Safety Recall Notice 19V-659

SAFETY NOTICE

SN675

SUBJECT: TL Upper Boom Cylinder Counterbalance Valve

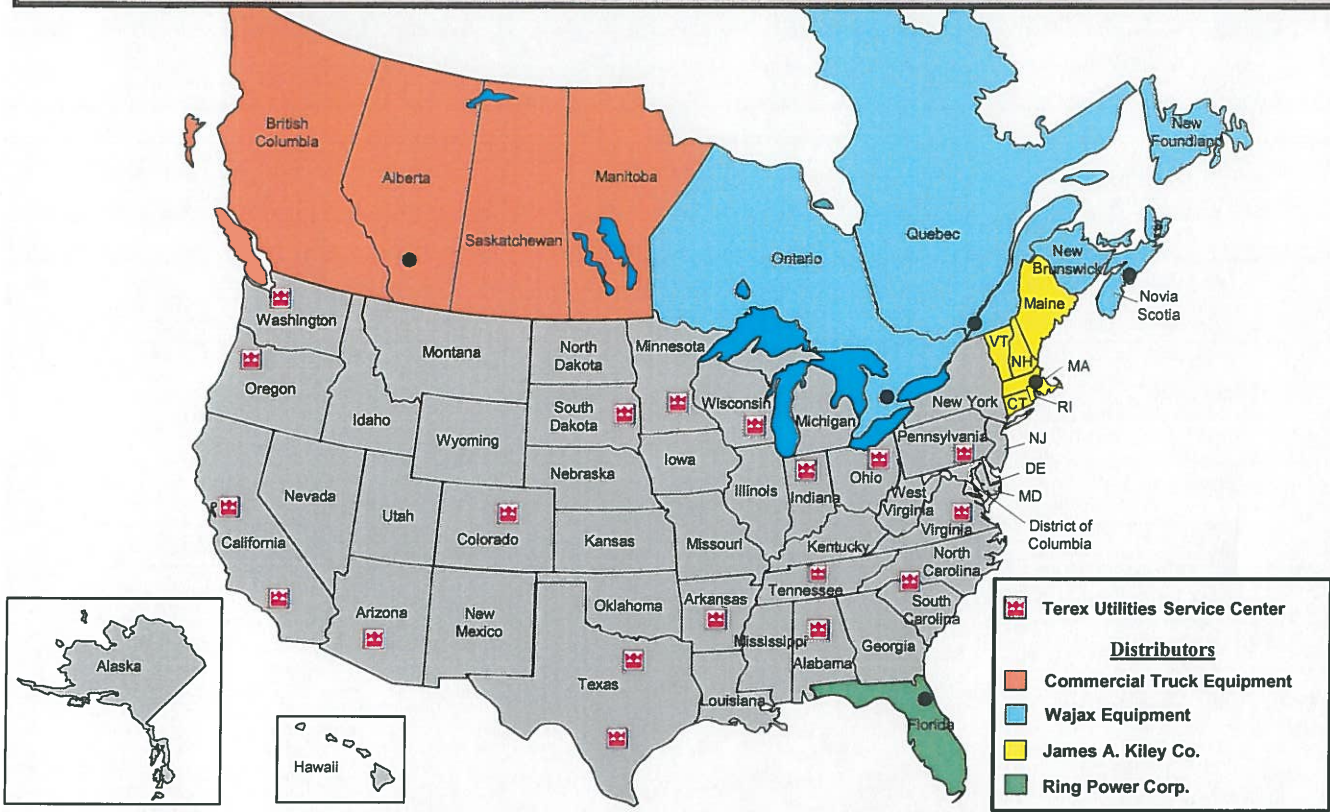
Immediately inspect the upper boom lift cylinder. If the cylinder matches the view below, look at the holding valve cartridge closest to the base end of the cylinder. If the marking is CBBA-2000 the valve needs to be replaced.

Only TL units built with the cylinders as shown in the view above are affected. If an owner contacts you call TEREX Utilities at 844-837-3948 and ask for the warranty department for instructions and to arrange shipment of parts.

Terex will replace holding valve cartridges determined to have the incorrect setting at no cost to the owner. Field Service kit Z1564 will be provided to the nearest Terex Utilities dealer or Field Service Technician for installation on your unit if it is subject to this recall.
